SAN FRANCISCO PLANNING DEPARTMENT

Addendum to Environmental Impact Report

Addendum Date: October 26, 2017
Case No.: 2014-0241ENV
Project Title: 1028 Market Street Project
EIR: 1028 Market Street Environmental Impact Report
Zoning: C-3-G District Downtown General Commercial
120-X Height and Bulk District
Block/Lot: 0350/002
Project Sponsor: Craig Young, LCL Global – 1028 Market Street LLC
(415) 890-6892
Lead Agency: San Francisco Planning Department
Staff Contact: Rachel Schuett – (415) 575-9030
Rachel.Schuett@sfgov.org

Figure 1: Modified Project Basement Floor Plan

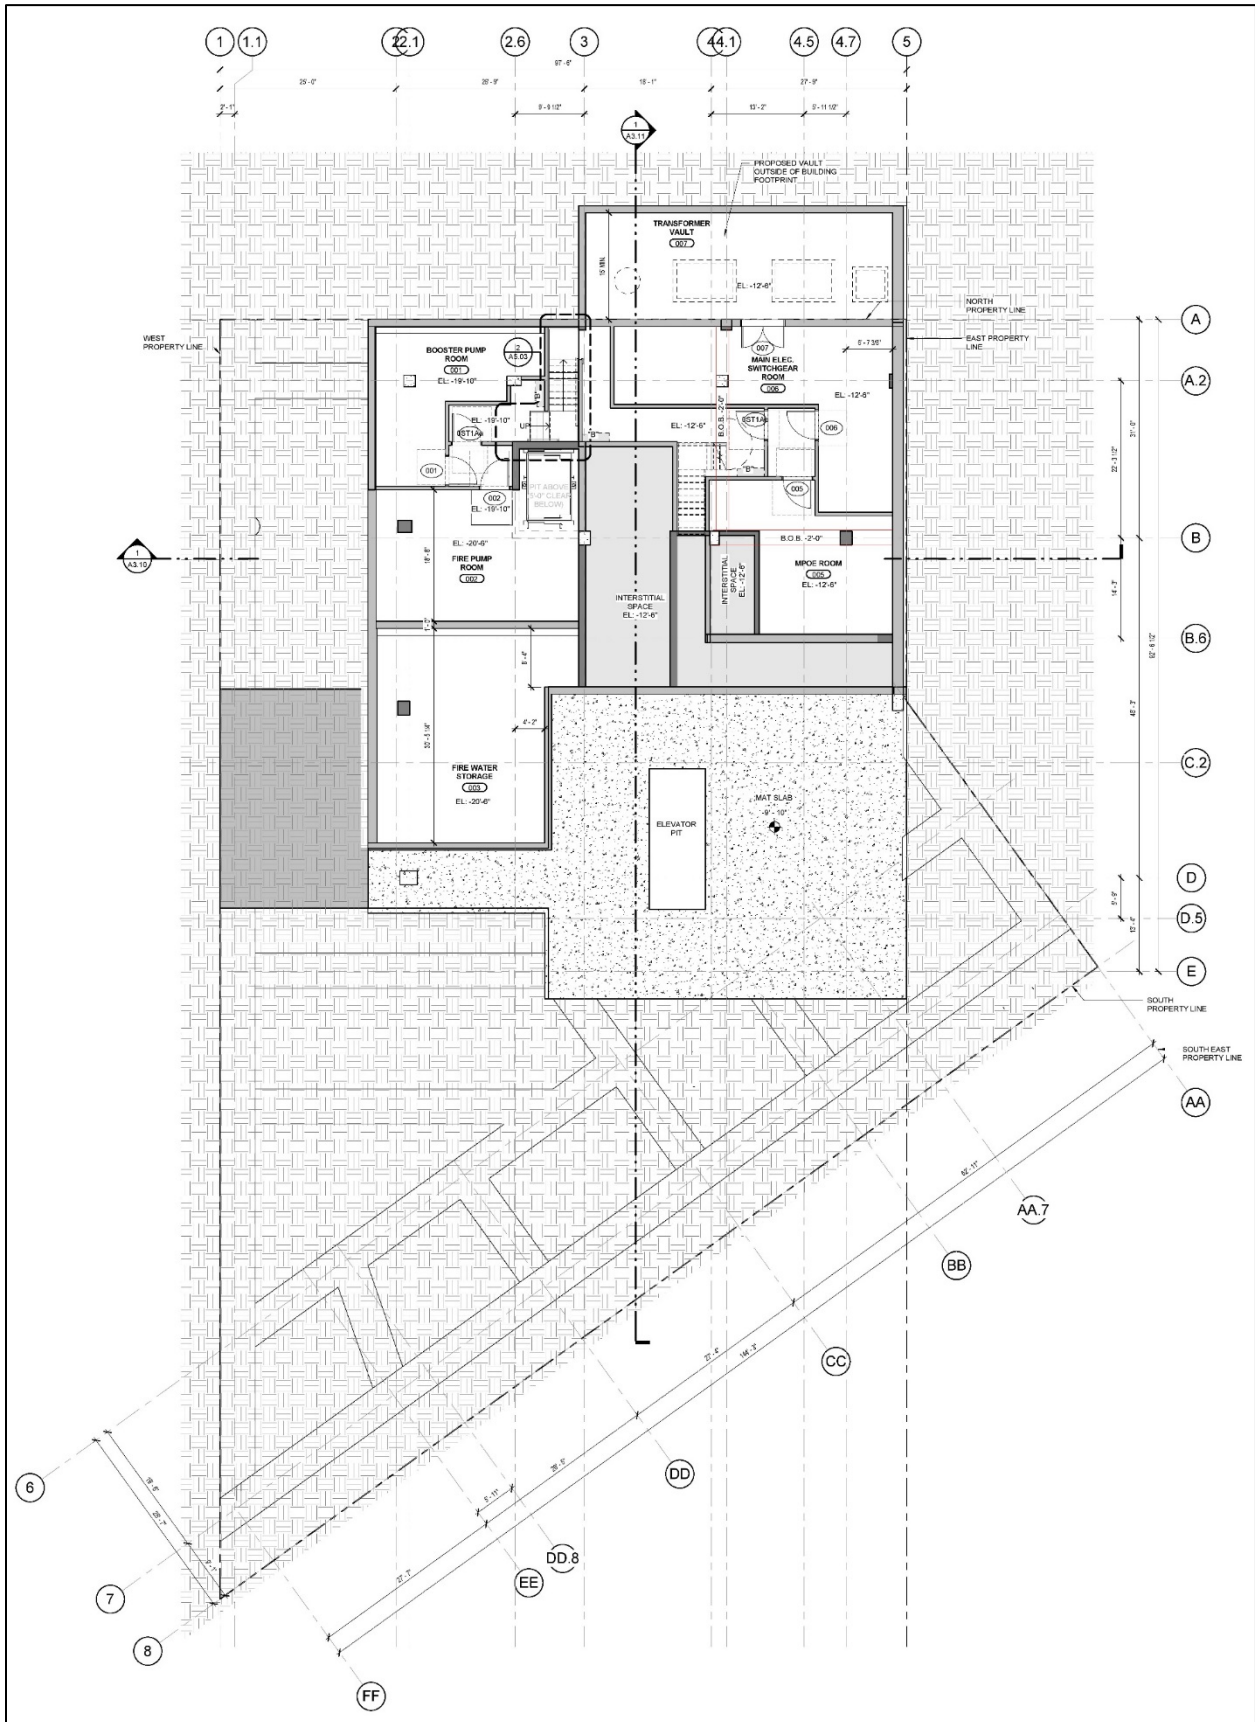
The Modified Project would not include the 42-space off-street basement parking garage and driveway curb-cut on Golden Gate Avenue proposed under the Original Project. With no on-site parking or loading, the footprint for the basement level would be reduced to 3,775 gsf and would accommodate mechanical uses. The modified basement would be accessible from an interior staircase in the building. The basement level under the Modified Project would be 11,781 gsf smaller than the Original Project's basement level (see Figure 1: Modified Project Basement Floor Plan in Exhibit A). Up to 3,900 cubic yards of excavated soil would be removed from the project site (approximately 5,900 fewer cubic yards of excavated soil than the Original Project). Excavation would have an estimated maximum depth of up to approximately 23 feet below ground surface including excavation for the elevator pit. Consistent with the Original Project, the transformer vault is proposed to be located outside of the property line below the sidewalk on Golden Gate Avenue.

Figure 2: Modified Project On-Street Loading

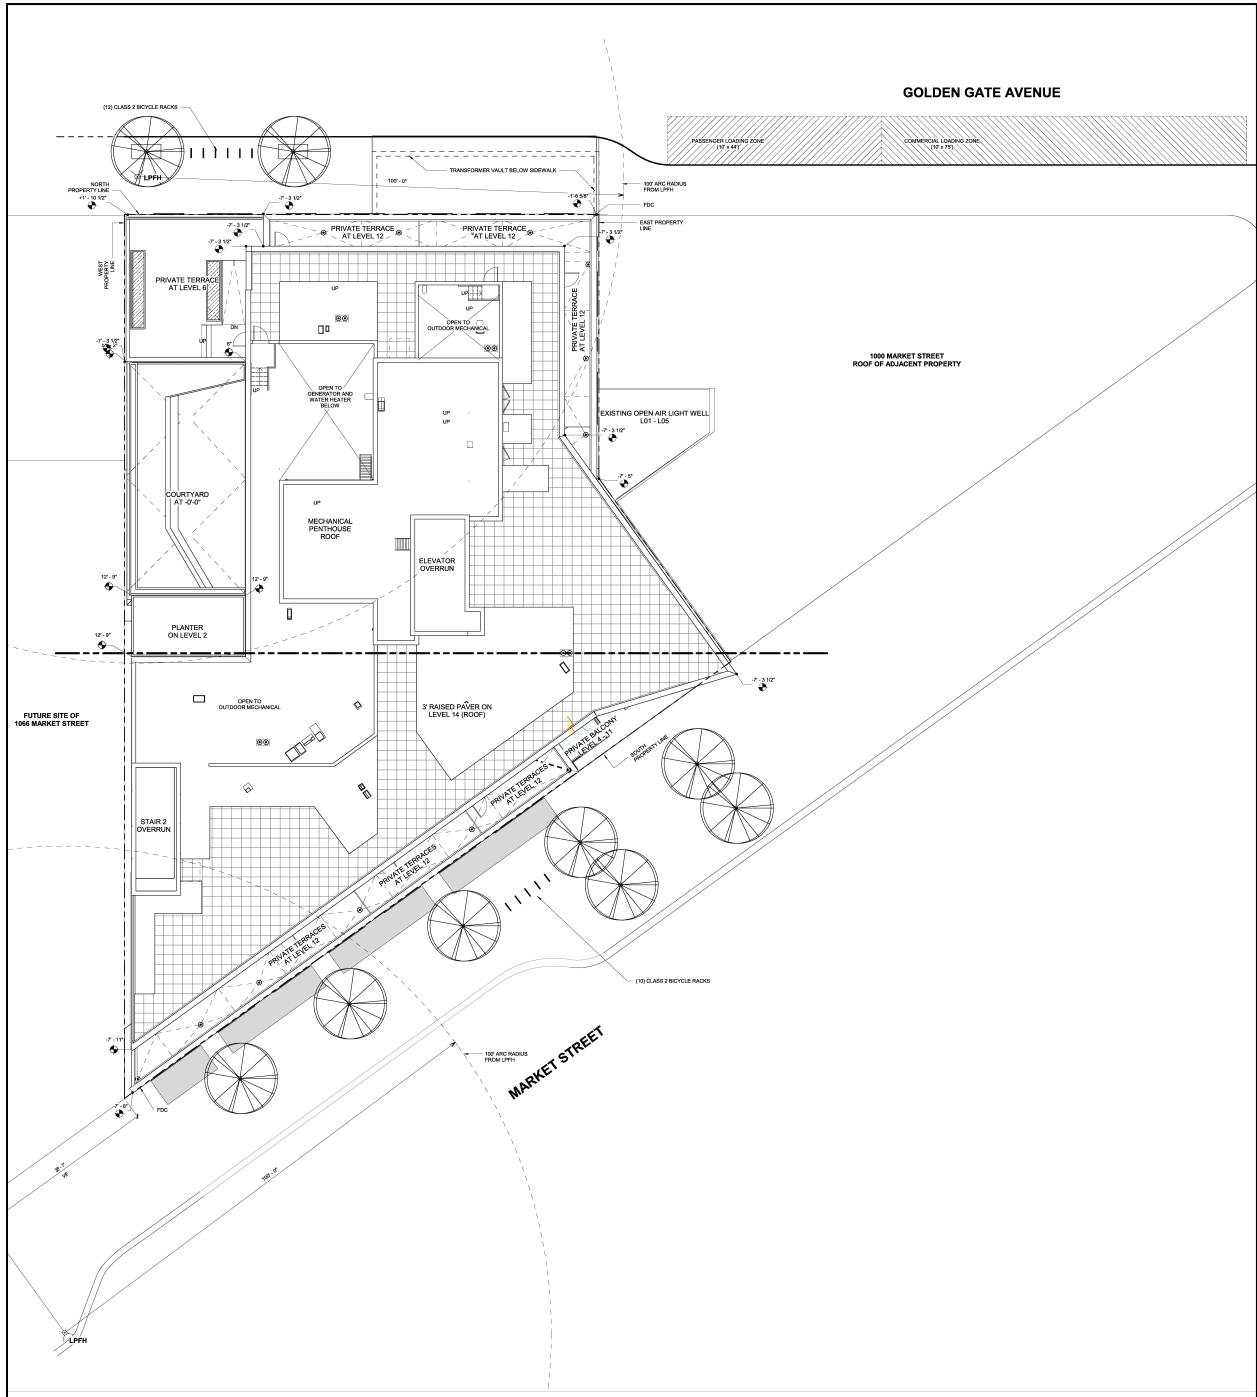
Similar to the Original Project, the Modified Project would seek to convert curb space on Golden Gate Avenue east of the project site frontage from on-street parking to commercial and passenger loading. The Modified Project would create a new approximately 44-foot-long passenger loading zone, and a longer (75-foot-long) commercial loading zone than the Original Project (25-foot-long) (see Figure 2: Modified Project On-Street Loading in Exhibit A).

The Modified Project would not include off-street freight loading or service vehicle loading spaces. Instead, the project sponsor would request that five on-street parking spaces on the south side of Golden Gate Avenue, east of the project site along the 1000 Market Street frontage, be converted to an on-street loading space, subject to approval from the SFMTA. Within this loading space, 44 feet would be designated as a passenger loading (white zone) space, and up to 75 feet would be designated as a commercial loading (yellow zone) space.⁶

Figure 3: Modified Project Level 1A Plan

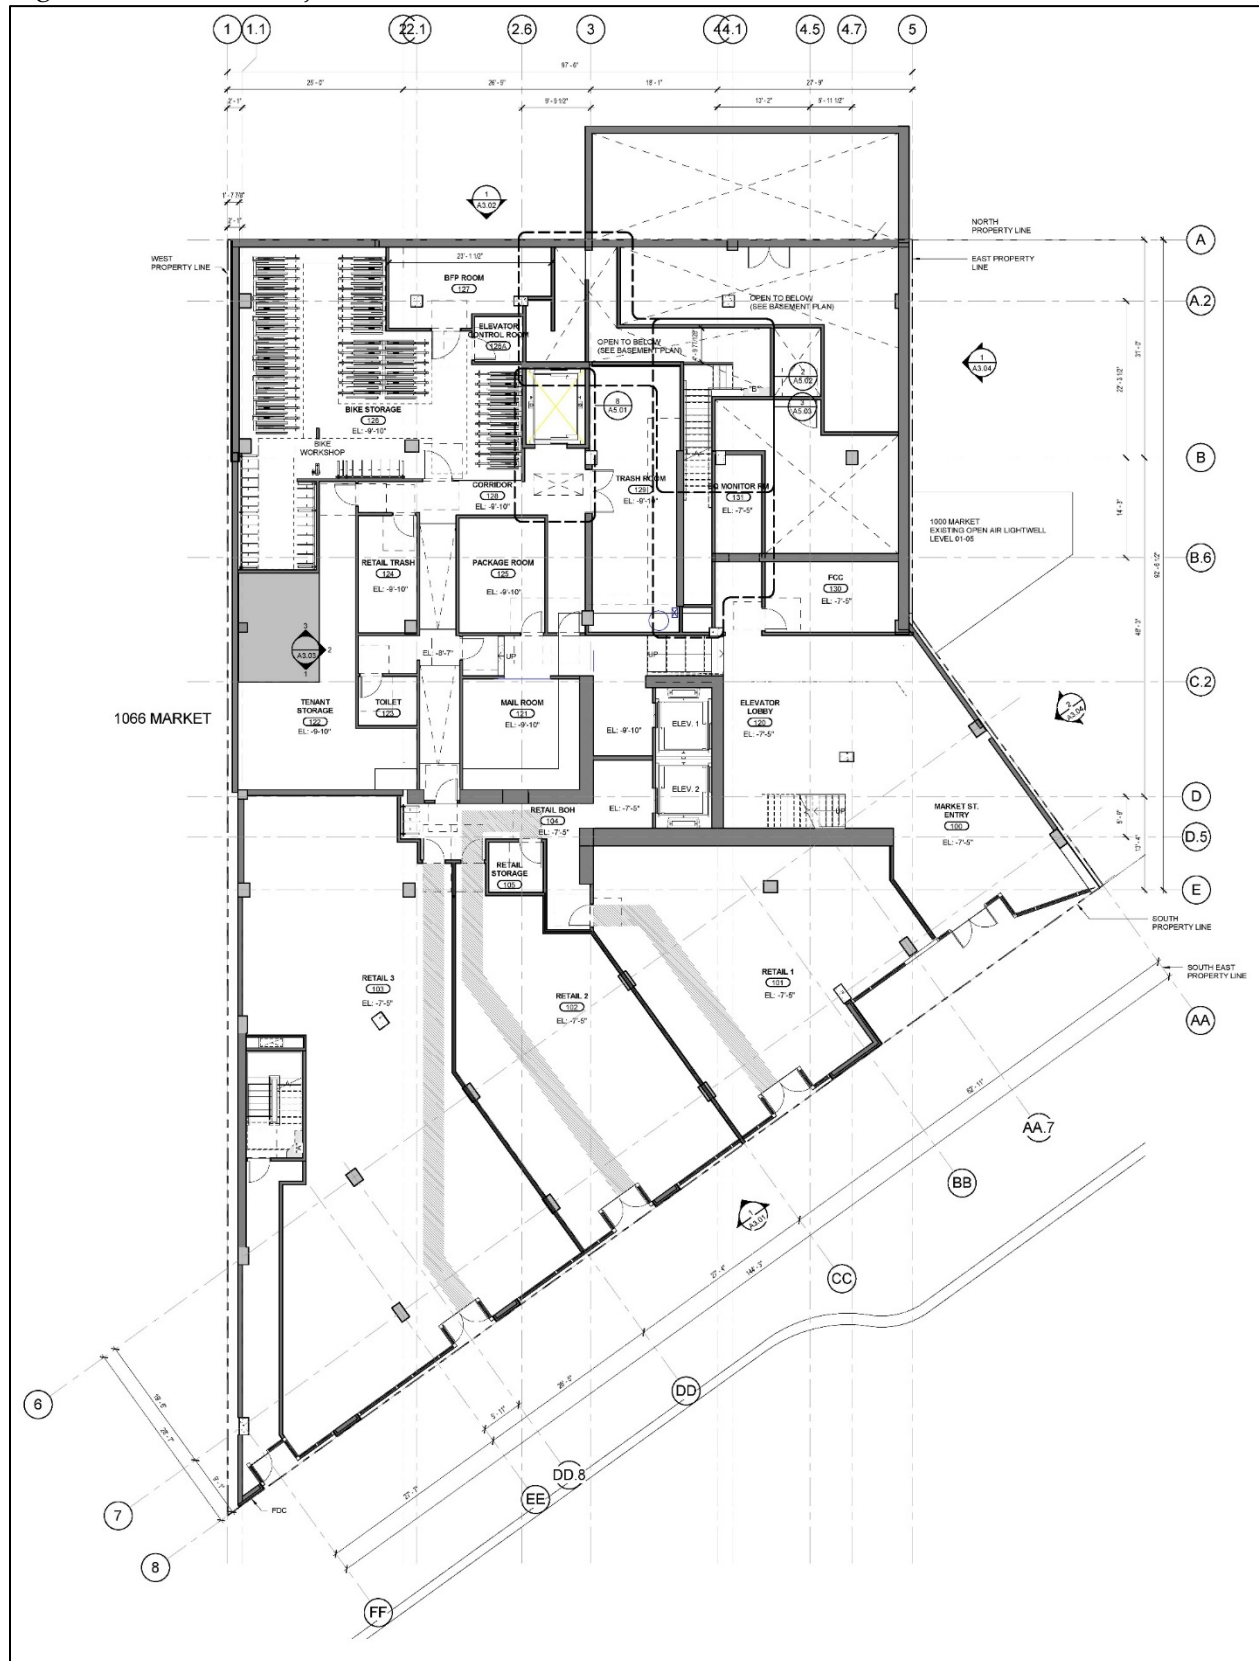
Similar to the Original Project, the ground floor would be composed of two partial levels corresponding to the stepped street elevations between Market Street and Golden Gate Avenue, now referred to as Level 1A and Level 1B in the Modified Project. Similar to the Original Project, the Modified Project would include three retail/restaurant tenant spaces fronting Market Street on Level 1A and one tenant space fronting Golden Gate Avenue on Level 1B. However, some of the tenant spaces would be reduced in size, for a total of 7,665 gsf of retail/restaurant uses (a reduction of 1,992 gsf from the Original Project). In addition, the Golden Gate Avenue retail space would be relocated to the east end of the frontage with a relocated fitness center occupying space at the west end of the Golden Gate Avenue frontage.

Similar to the Original Project, the main residential entrance would be located at the east end of the Market Street frontage on Level 1A and would include a lower lobby, mail room, and back of house functions. In the Modified Project, Level 1A would also include a package room, tenant storage room, bicycle storage room and bicycle workshop, as shown on Figure 3: Modified Project Level 1A Plan in Exhibit A. The bicycle storage room would provide 126 class 1 bicycle parking spaces, or three more class 1 spaces than the Original Project. No class 1 bicycle spaces for the retail/restaurant use would be provided. Under the Modified Project, 22 class 2 bicycle parking spaces would be provided for the residential and retail/restaurant uses (the same number as the Original Project).

Figure 4: Modified Project Level 1B Plan

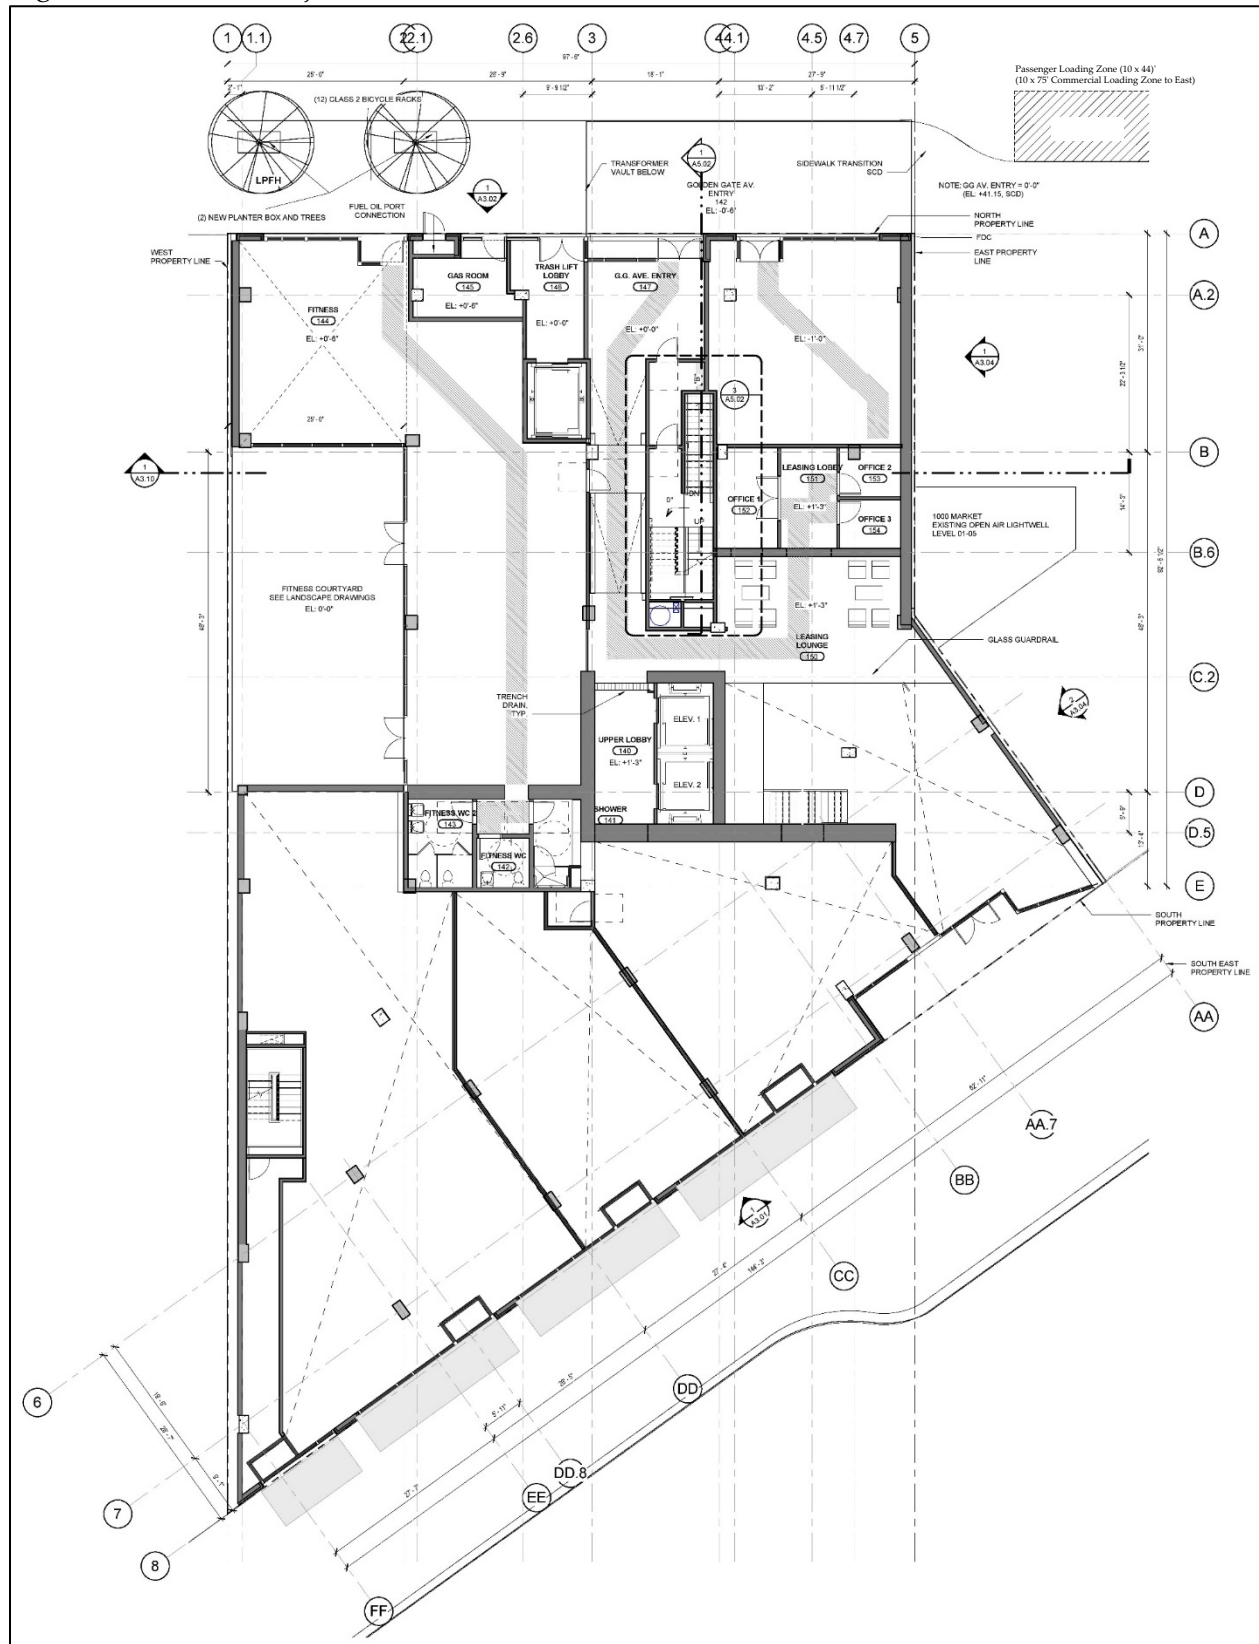
Similar to the Original Project, Level 1B would include an upper lobby with a secondary residential entrance from the Golden Gate Avenue frontage. However, in the Modified Project configuration, mail carriers or package delivery vendors entering from Golden Gate Avenue on Floor 1B would use an elevator in the upper lobby down to Floor 1A where the mail room and package room would be located. Similar to the Original Project, Level 1B would also include utility rooms with service entrances from the Golden Gate Avenue frontage, including a new trash/move-in lift room. In the Modified Project, Level 1B would also include a leasing office. The fitness center and courtyard, previously located on the 2nd floor, would be relocated to Level 1B, as shown on Figure 4: Modified Project Level 1B Plan in Exhibit A.

Figure 6: Modified Project Golden Gate Avenue (North) Elevation

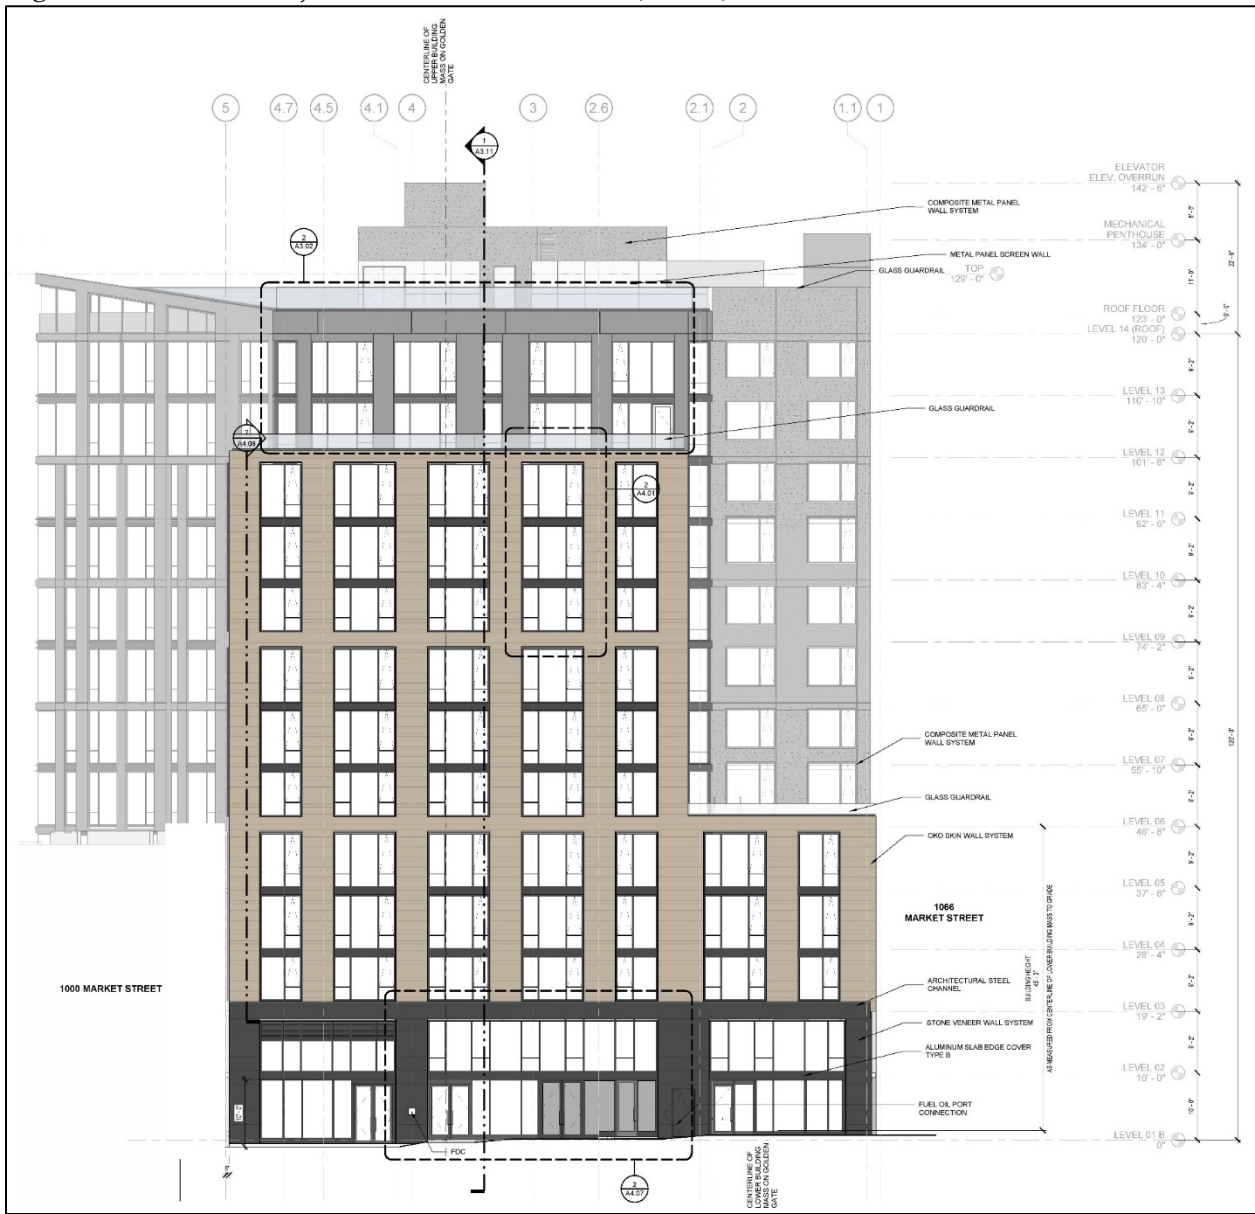
Similar to the Original Project, the Market Street (south) elevation and the Golden Gate Avenue (north) elevation would have a stepped and layered composition articulated through the use of different building materials. However, the Modified Project would replace one of the proposed materials, brick cladding, with a rain screen material.¹ See Figure 6: Modified Project Golden Gate Avenue (North) Elevation, and Figure 7: Modified Project Perspective View from Golden Gate Avenue (Looking Southeast) in Exhibit A. The rain screen, also known as Oko skin, has tiled units that are larger than those of the original thin brick scheme, and would be designed in a plank format (approximately 6 inches nominal height) with a masonry texture and natural color variation similar to coursed brick. The rain screen would replace brick veneer used for the Market Street (south) elevation at the 3rd through 9th stories, where the seven westernmost window bays would have been clad with brick veneer to form an 11-story façade plane along the Market Street property line. Similarly, on the Golden Gate Avenue (north) elevation, brick veneer used for the northeast elevation (also featuring window walls and zinc paneling) would be replaced with rain screen.
